San Juan Police Building Expansion

Addendum NO. 02

CSP No. 25-004-3-13

Date: 03/11/2025

WATER TOWER

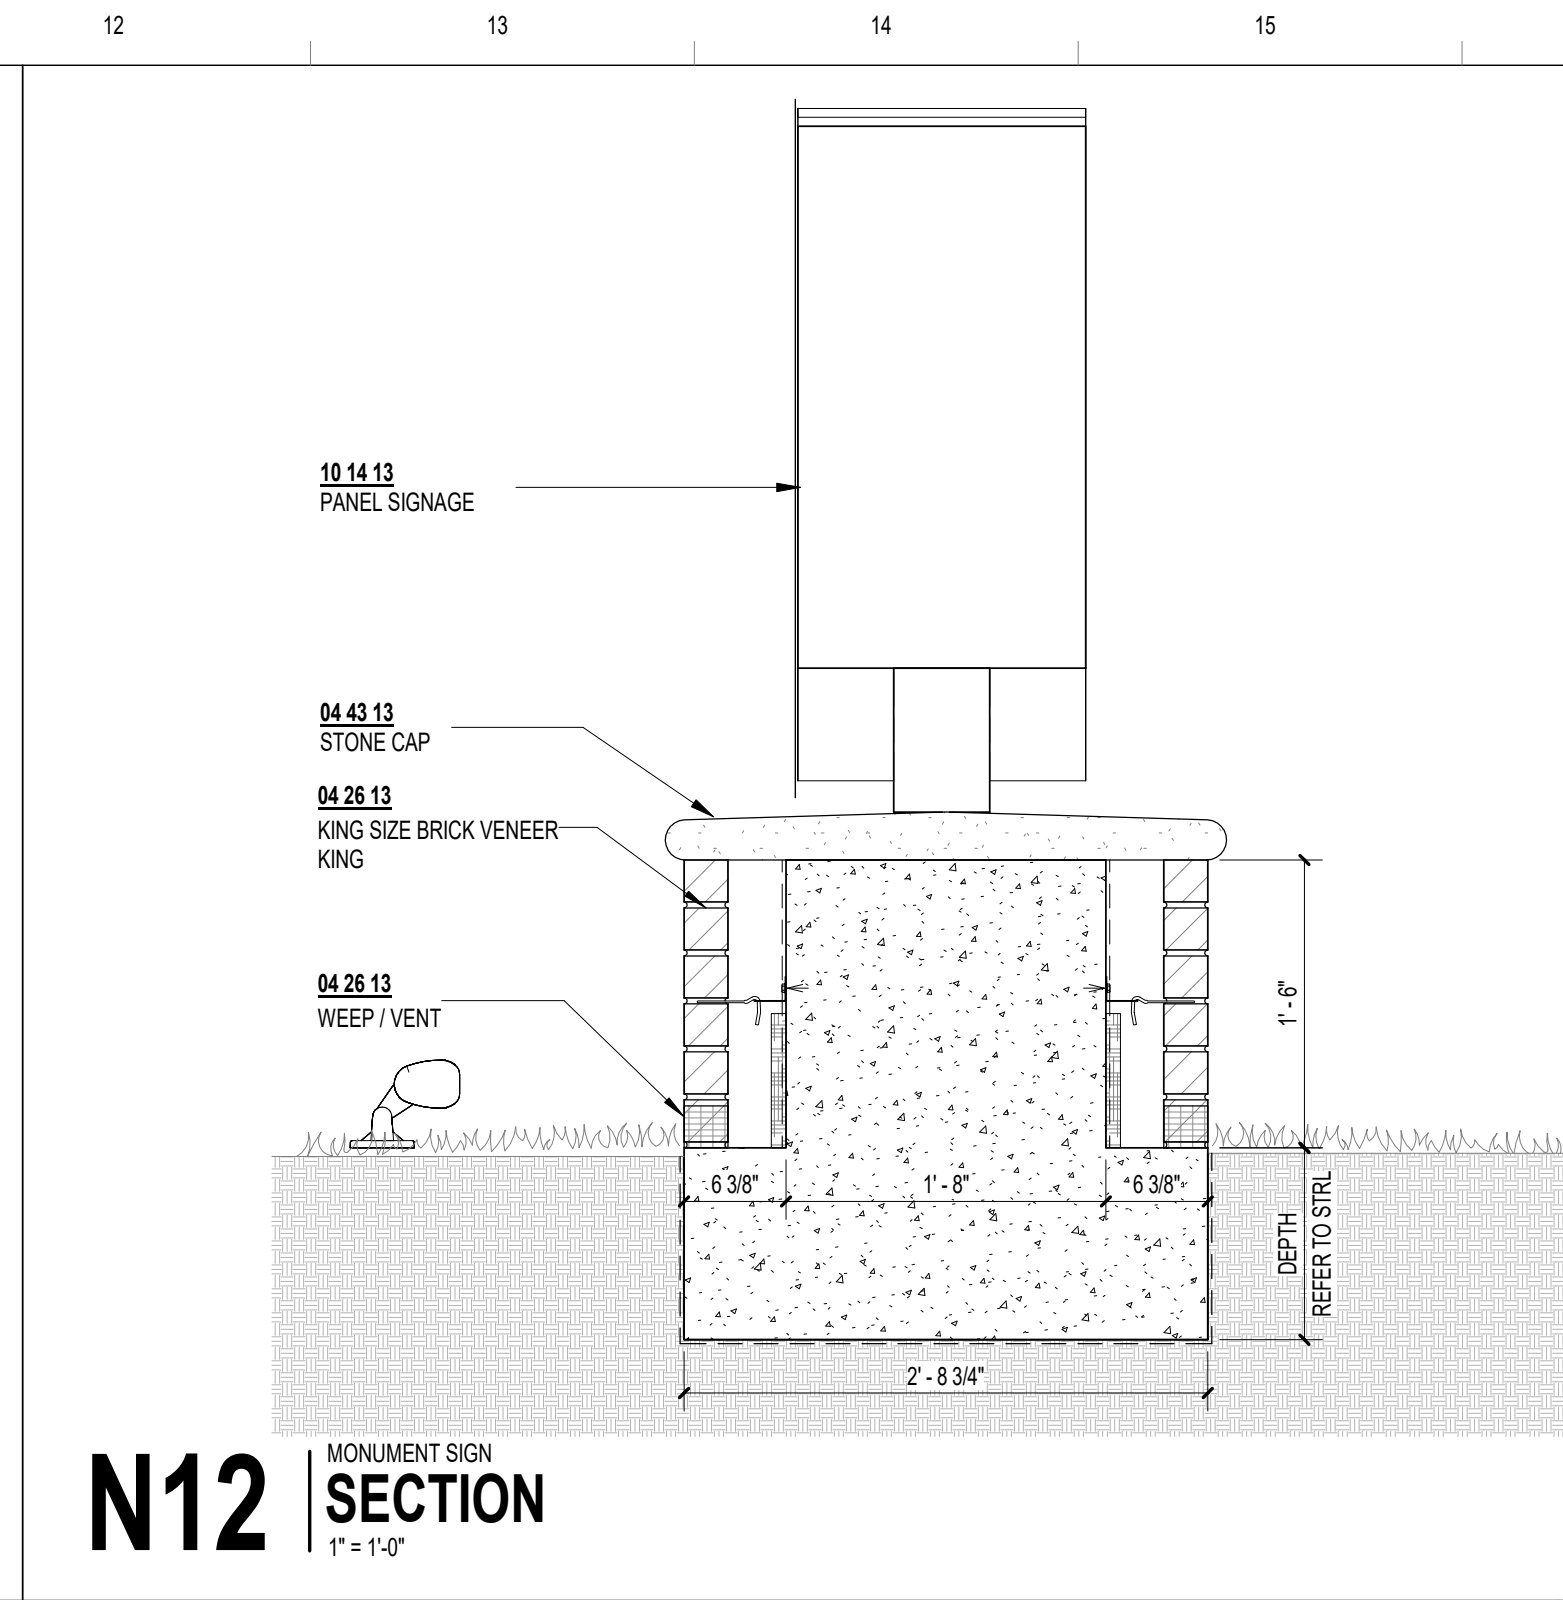
Sheet AS102 – ENLARGED SITE PLANS, Delete Sheet AS102 in its entirety.

Replace with revised SheetAS102 (refer to attached).
